INNER WEST COUNCIL

DEVELOPMENT ASSESSMENT REPORT

Application No.	10.2019.109.1
Address	164 Frederick Street, Ashfield
Proposal	Demolition of existing structures and construction of a 3 storey serviced apartment building with 33 rooms, basement car parking, signage and associated landscape works.
Date of Lodgement	18 July 2019
Applicant	Sonar Australian PTY LTD
Owner	Sonar Australian PTY LTD
Number of Submissions	Two (2)
Value of works	\$4 935 695.00
Reason for determination at Planning Panel	Clause 4.6 variation exceeds 10%
Main Issues	Non-compliance with development standards, streetscape impacts, amenity impacts to neighbours and traffic/parking
Recommendation	Refusal
Attachment A	Reasons for refusal
Attachment B	Plans of proposed development
Attachment C	Conditions of Consent

CALCULATIONS	
SITE AREA	761m ²
SITE COVERAGE	429m ² 56%
PRIVATE OPEN SPACE	332m ² 44%
COUNCIL FSR	1:5:1
PROPOSED FSR	1:3:1

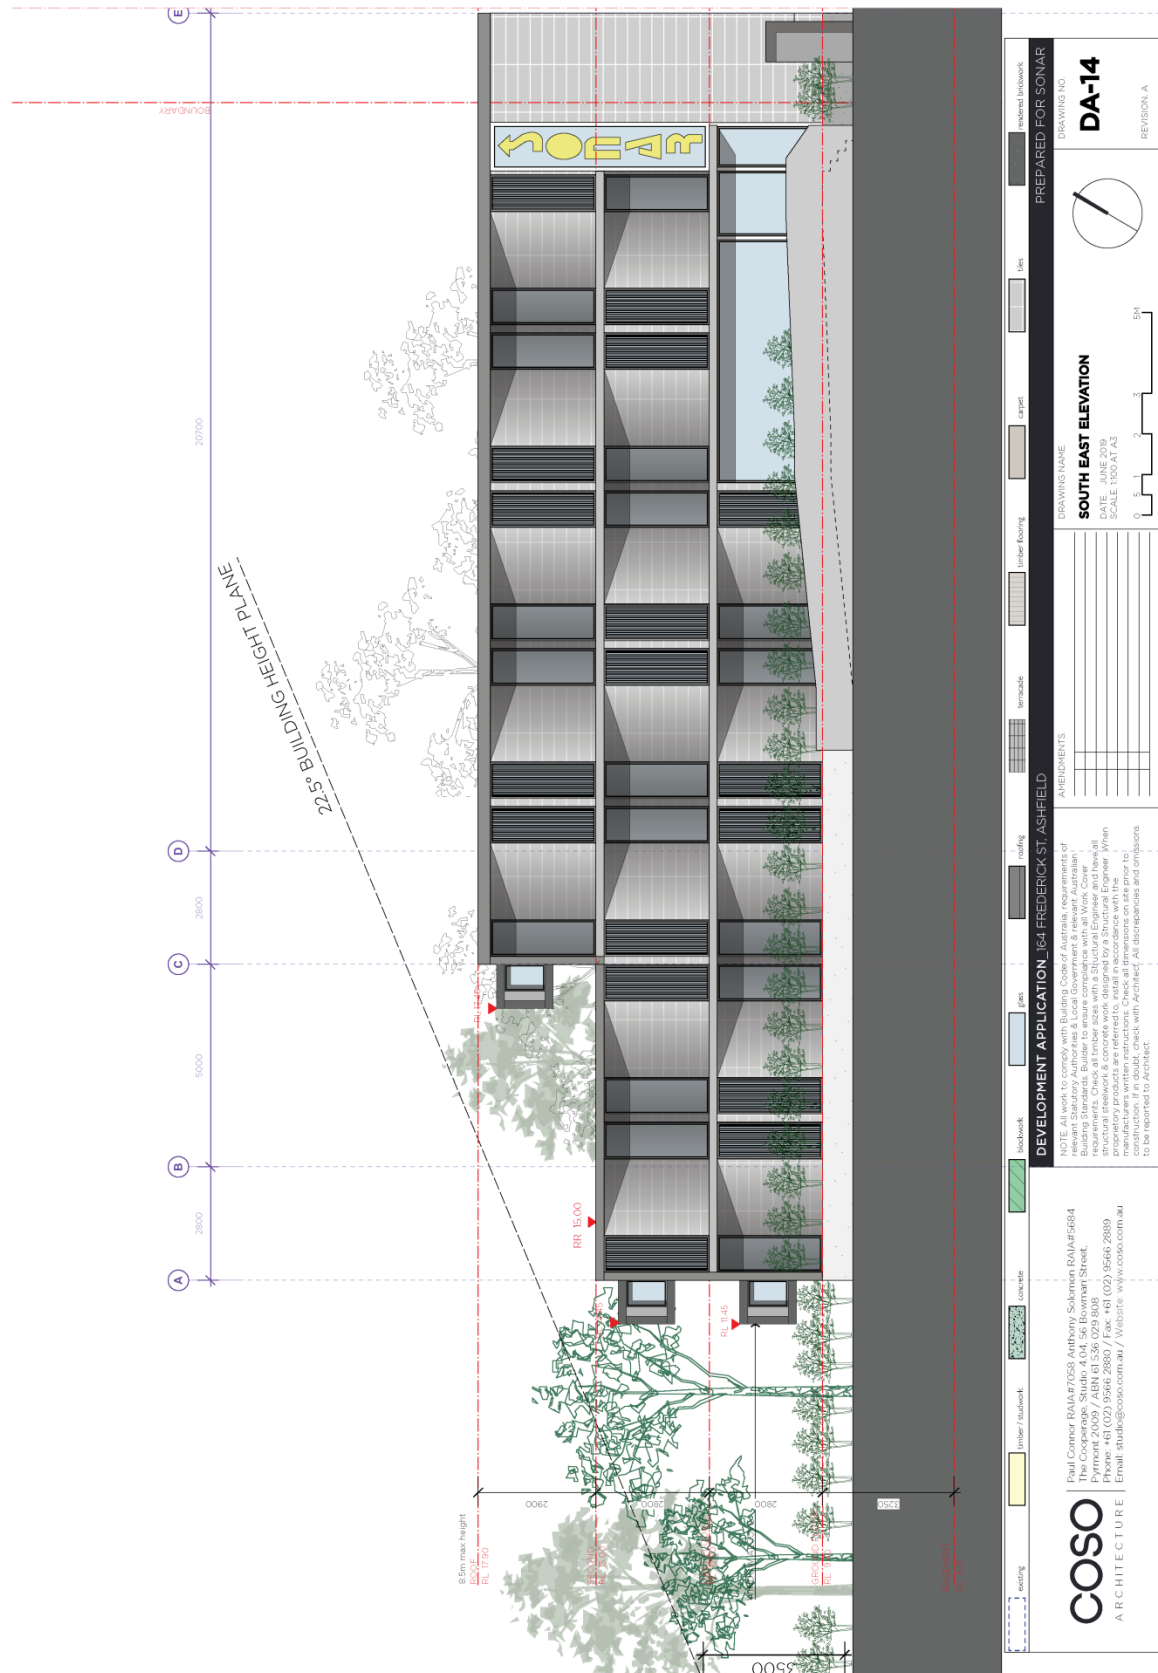
Plans provided by the applicant currently fail to represent the correct height of the proposed building as they incorporate an inaccurate 8.5m maximum height line. This has been analyzed against the proposed roof RL and existing natural ground RL which has highlighted the proposed height variation.

- *The panel considers that in its current form the building provides a poor presentation of its front address to Frederick Street and that the proposed entrance creates a pinch point as a result of its location and change of height of the finished floor level relative to the ground level. The panel considers that any change of level should be omitted, or managed within the building rather than its external interface.*

- *The proposed communal open space to the rear does not provide an acceptable relationship with the ground floor*

Plans currently provided do not detail the proposed location of key services such as fire hydrant boosters or electrical substations. These services are required under the BCA and have significant potential to disrupt streetscape and good urban design outcomes if not appropriately treated/screened.

The proposal is recommended for refusal based upon the matters discussed within this report, however in the event that amended plans are submitted or that the development application is approved then it is recommended that a condition of consent requiring the display of such services upon the stamped plans be imposed.
